United States Patent and Trademark Office

| APPLICATION NO. | FILING DATE | FIRST NAMED INVENTOR | ATTORNEY DOCKET NO. | CONFIRMATION NO. |
|---------------------------------|-------------|----------------------|-------------------------|------------------|
| 10/820,266 | 04/08/2004 | Takeshi Masutani | MAT-8533US | 7547 |

| | Application No. | Applicant(s) | | | | | |
|---|---|--|--|--|--|--|--|
| Office Action Summary | Examiner | Art Unit | | | | | |

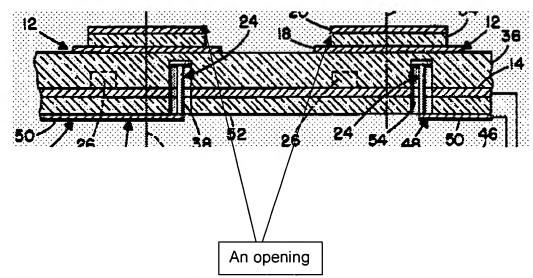
With respect claim 1, Wong et al. discloses a multiple antenna comprising a ground electrode (14); a dielectric substrate (36) (see column 3, line 41) disposed on a top surface of the ground electrode (14); a planar antenna electrode (12) disposed on a top surface of the dielectric substrate (36); feeding terminal electrically coupled to the planar an antenna (see fig. 1-3), an upper antenna electrode (20) disposed above the planar antenna electrode (12) with a given space in-between such that the upper antenna electrode faces the planar antenna electrode (see fig. below); and a feeding section electrically coupled to the upper antenna electrode (see fig. 2), wherein the upper antenna electrode (20) has an opening facing the planar antenna electrode (12) (see fig. below).
